GHP610(W)/611(W)/620(W)/621(W) Firmware Release Notes

GHP610(W), GHP611(W), GHP620(W), GHP621(W)

PNP SERVICE

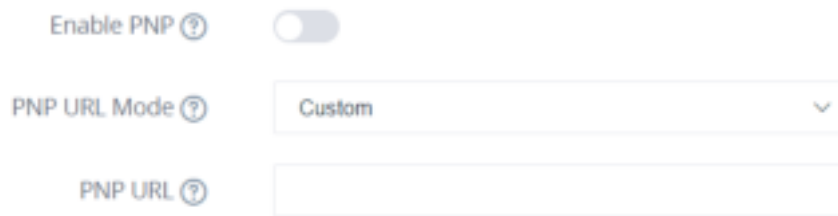
- Improved Web UI display strings
- Improved Web UI tooltips
- Added Support of Redial Expiration [REDIAL EXPIRATION]
- Added Support of PNP Service [PNP SERVICE]
- Added Support of keep alive to NAT Traversal
- Added Support of local call features [LOCAL CALL FEATURES]
- Added Support of “*87” as blind transfer feature code with Local Call Features enabled

Enable PNP: Configure whether to enable PNP function. After enabling, automatic configuration is supported, and up to 100 devices can be configured.

PNP URL Mode: Select the PNP URL mode, including local and custom, custom does not support to fill in the local machine related address.

PNP URL: The configuration terminal can take the server address of the configuration file. The server address can be the IP address of the terminal that provides PNP services. It cannot be configured as a local related parameter.
